Llano Masonry

Submittals

Project: Texas Tech University Chapel

Item: stone anchors

#406 STONE ANCHOR

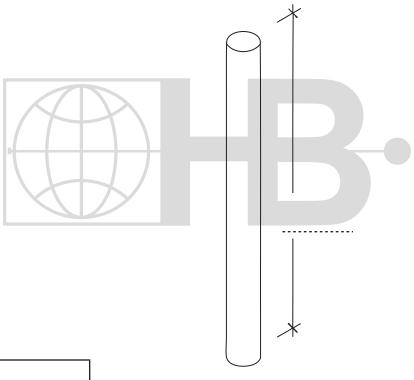
Notes: We propose to use all stainless steel anchors. At locations of banding and wall

cap, we will use an anchor pin. At locations of larger bands, soffits and

#439 STONE ANCHOR

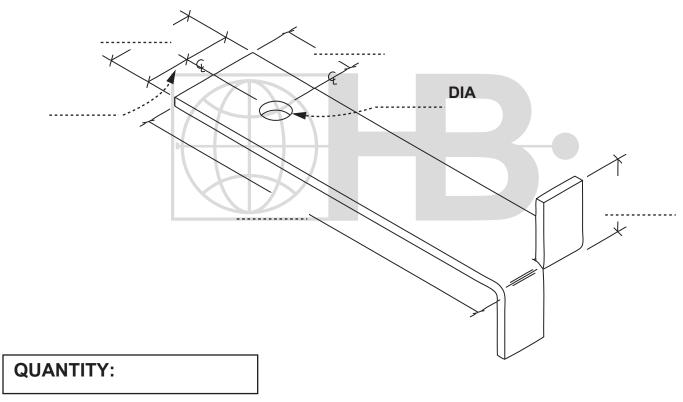
projections we will use a split-tail anchor installed at head joints.
